Lower Thames Crossing

5.4.1.1 Draft Agreed Statement of Common Ground between (1) National Highways and (2) the Environment Agency (Clean version)

**DATE: November 2023
DEADLINE:7**

This is an Agreed Draft Statement of Common Ground with matters outstanding.

Plate 3: Cross section of the existing Coalhouse Point flood defence

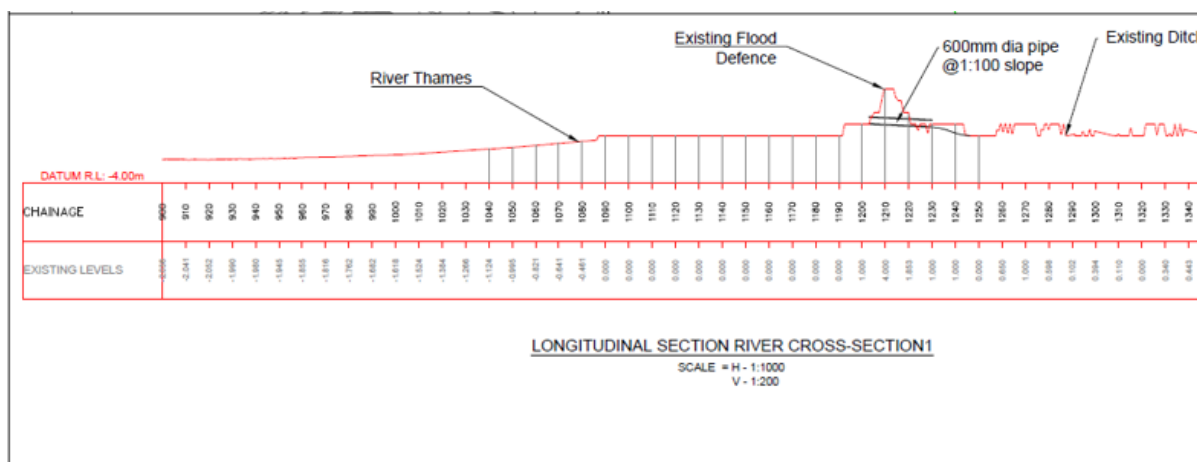
The existing ground levels and tidal regime has informed the potential location and size of the structure, relative to the existing flood bund. The crest of the flood bund sits at approximately 4.0m AoD, whilst its base on the river side is around 1.0m AoD. The existing ditch directly to the north of the flood defence is at 0.0m AoD. Plate 3 provides a cross section of the existing flood defence.

Figure 1: Impact of increased defence levels on breach start and end times at Mardyke Sluice breach (based on future level for Option 1.4 in 2127)

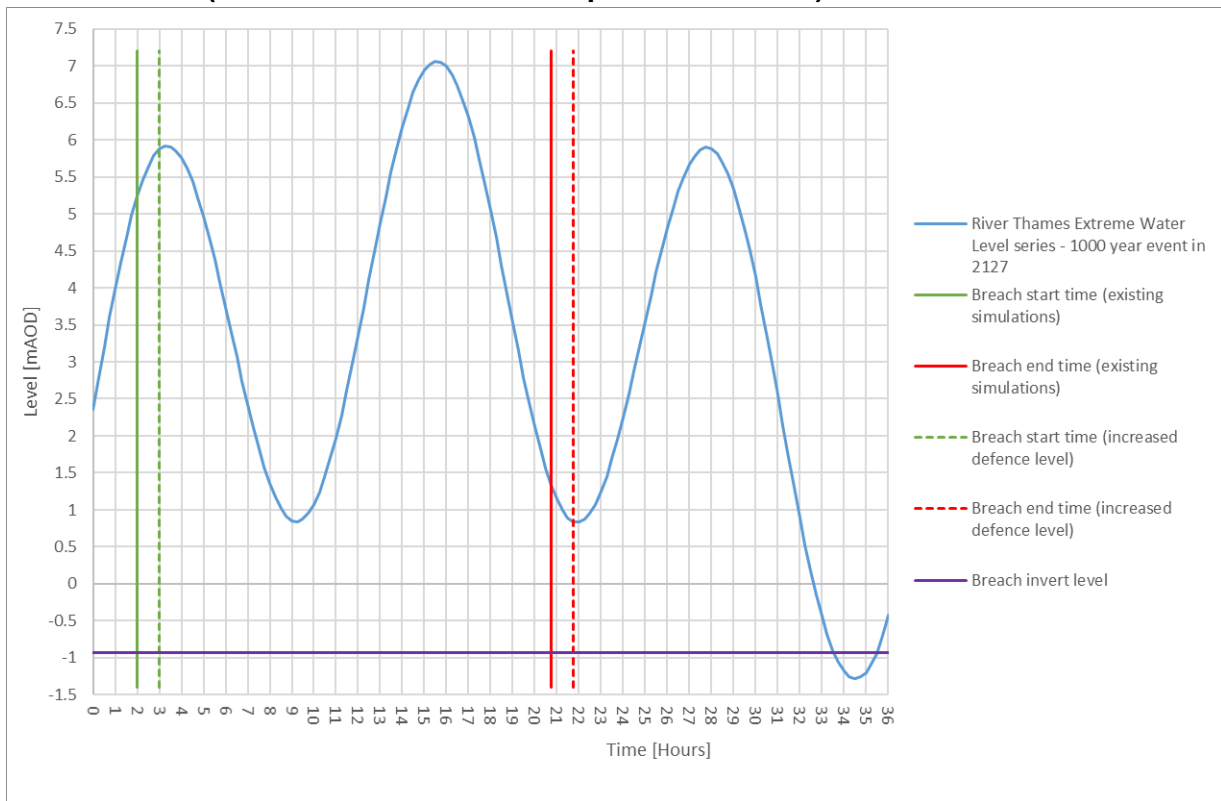
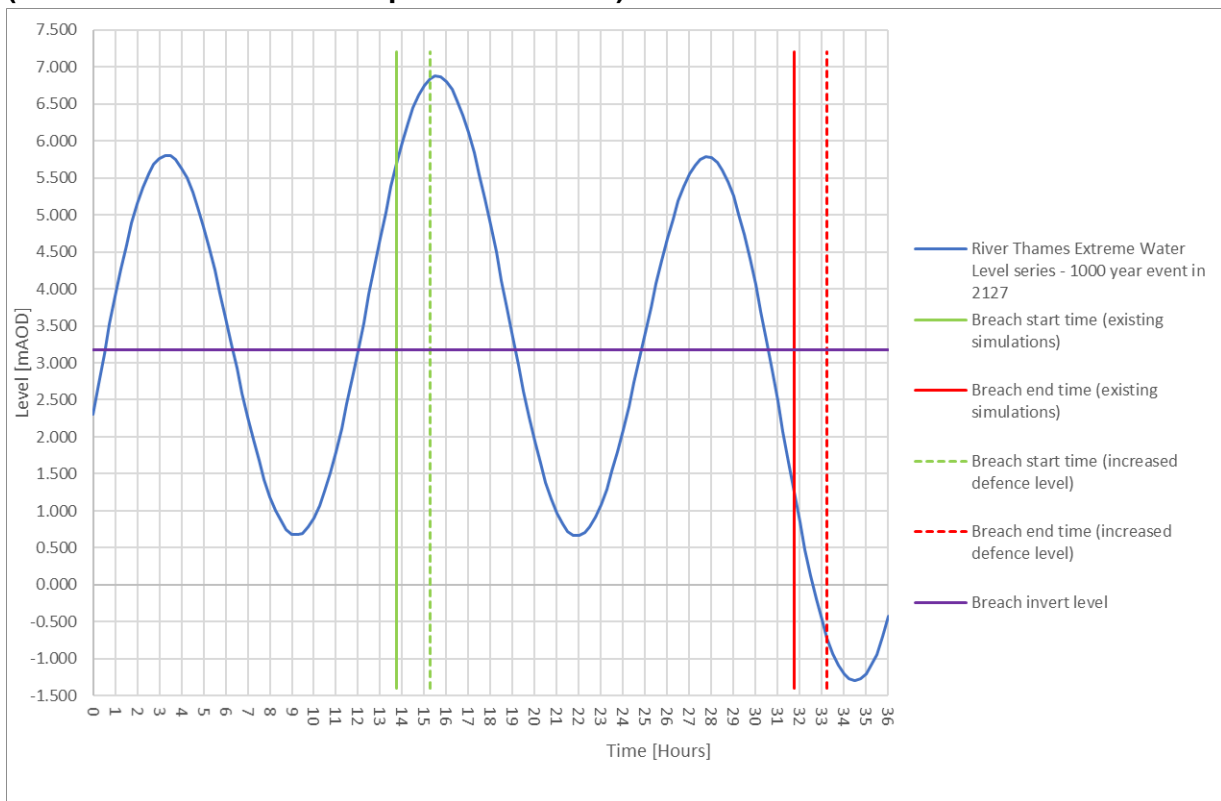
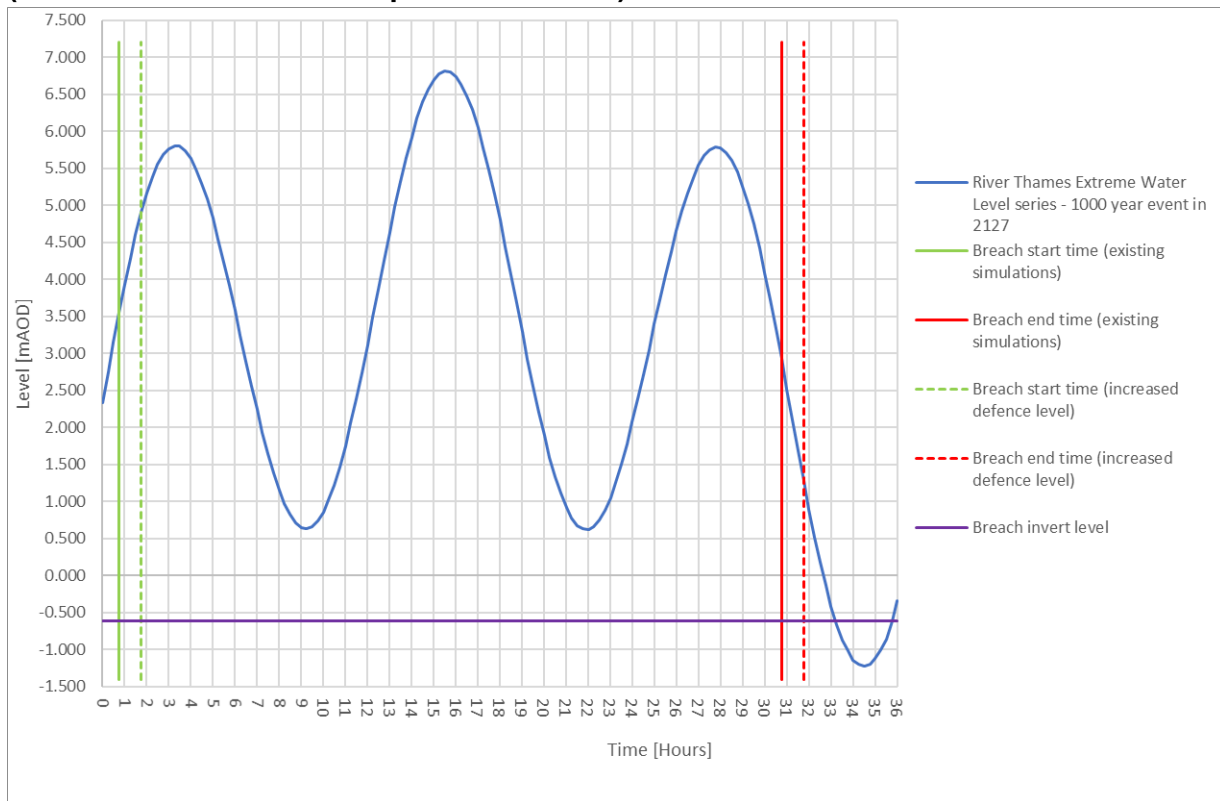
- 2.2.4 Figures 1 to 3 show the influence of increasing flood defence levels on breach start and end times for the LTC FRA breach simulations. The change in breach start and end times is shown for the highest required future defence levels (i.e. the future defence levels that are most different to those assumed in the LTC FRA breach simulations, highlighted in orange in Table 2).

2.2.5 Figures 1 to 3 show that for all LTC FRA breach locations, applying higher flood defence levels results in a delay in the start and end times of simulated breaches. An inspection of Figures 1 to 3 indicates that the reduction in initial breach flows resulting from increased defence levels (due to a delayed start) would exceed the gain in breach flows at the end of the simulated breach event, as River Thames flood levels are higher at the start of simulated breach events than at the end of the events (and for TIL005 there would be no gain in breach flows at the end of the simulated breach event, as River Thames levels would be below the TIL005 breach invert level at the end of the simulated beach). There would therefore be an overall reduction in simulated breach flood volume as a result of increasing flood defence levels.
